Scintillator module design concept

Preliminary Design Review

7th February 2025

Modules arranged in planes

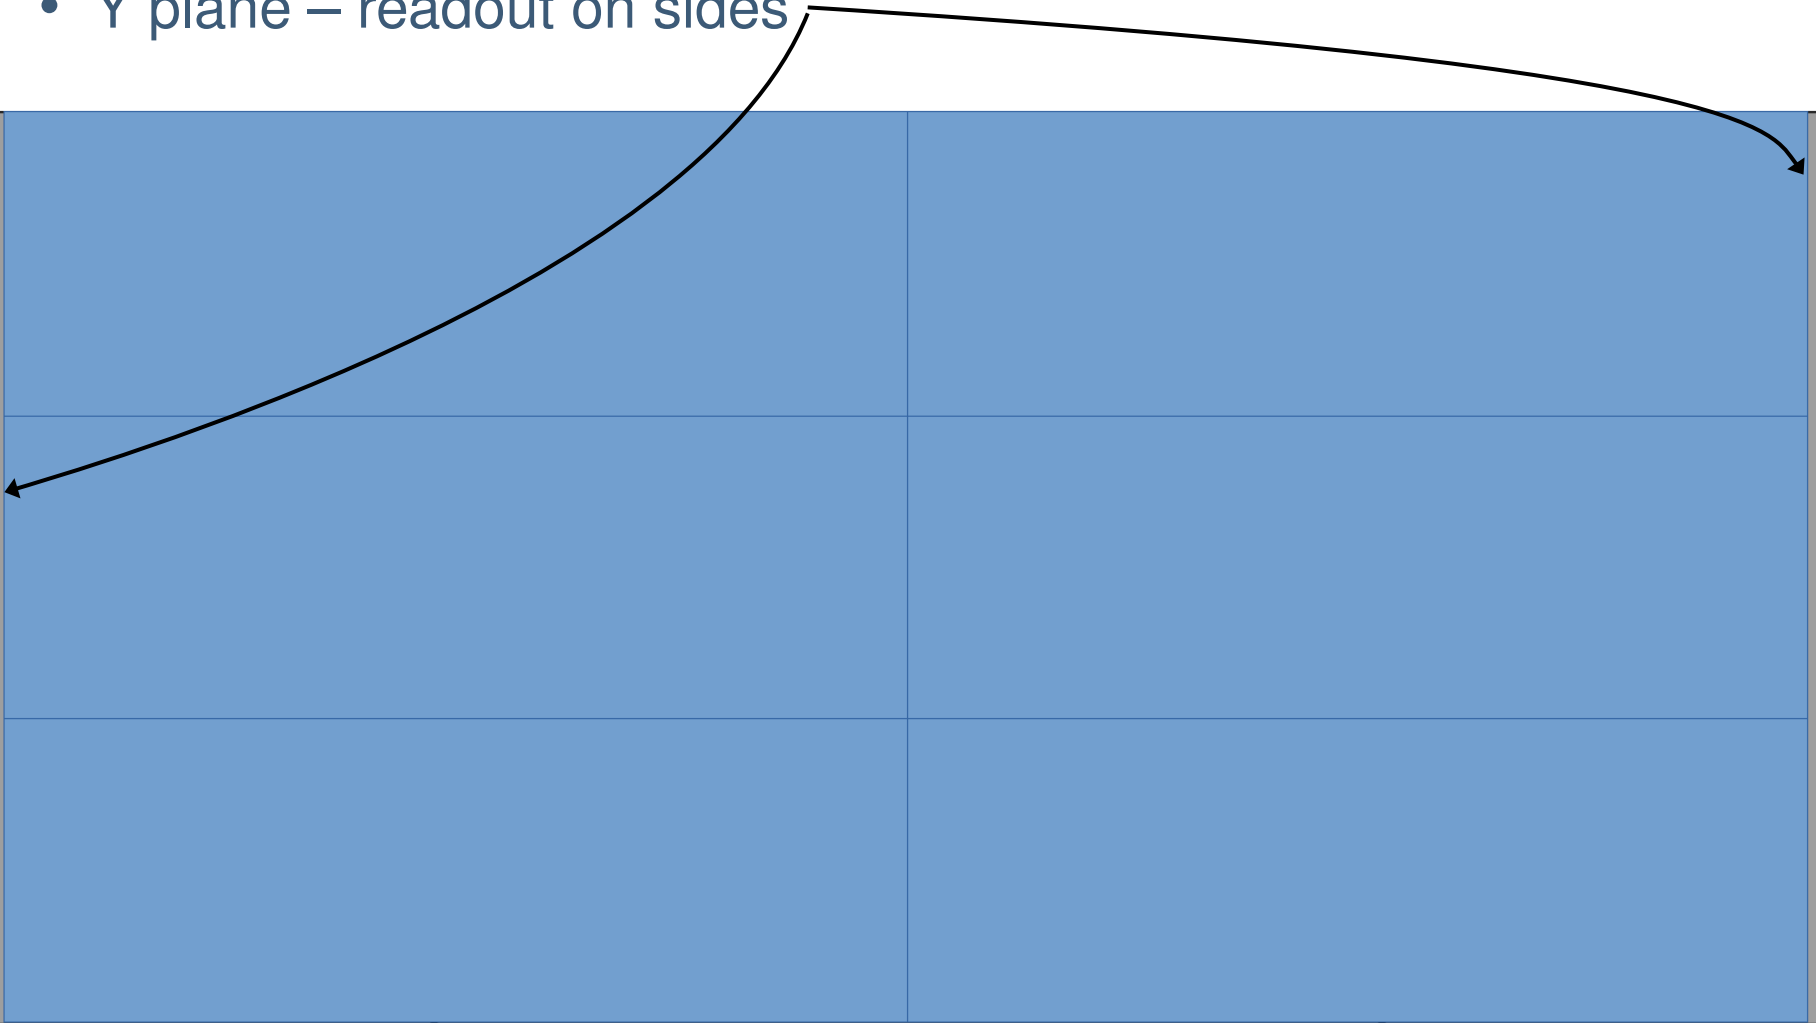
Clarify centering, Y coverage includes all U/V coverage

Fiber manifolds

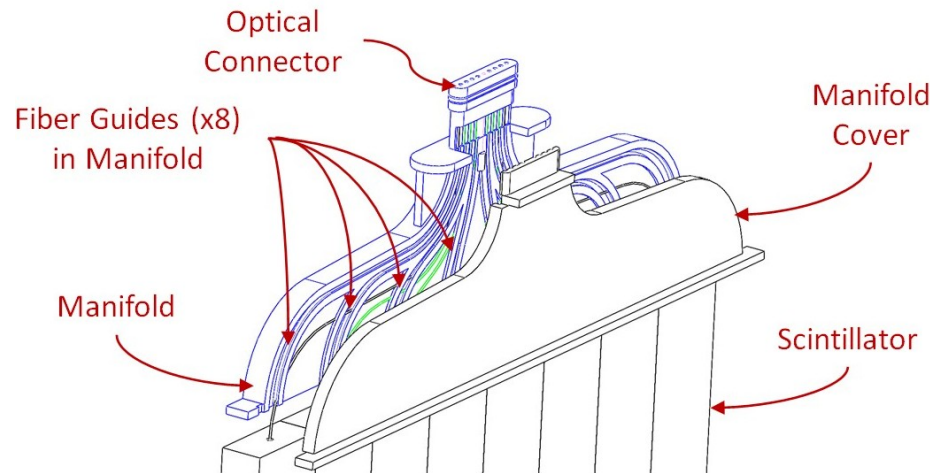
Explain why this is needed
